UNITED STATES PATENT AND TRADEMARK OFFICE

| APPLICATION NO. | FILING DATE | FIRST NAMED INVENTOR | ATTORNEY DOCKET NO. | CONFIRMATION NO. |
|---|-------------|----------------------|---------------------|------------------|
| 10/583,653 | 03/28/2007 | Frank Brode | 02316.2395USWO | 3708 |

Office Action Summary

DETAILED ACTION

FIG. 2

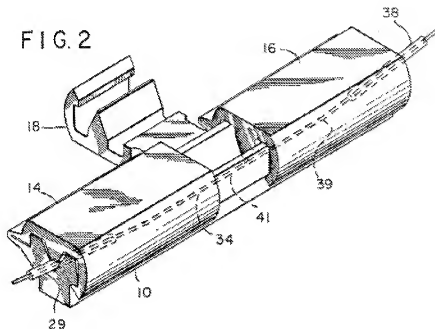
Re claim 38, see figures 2, 7 and 8 wherein the housing comprises at least two parts (top and bottom parts), with V-shaped grooves having been worked into a bottom part and a top part being configured to receive an inserted optical waveguide that is pushed into one of the V- shaped grooves when the bottom part and the top part are pushed together.
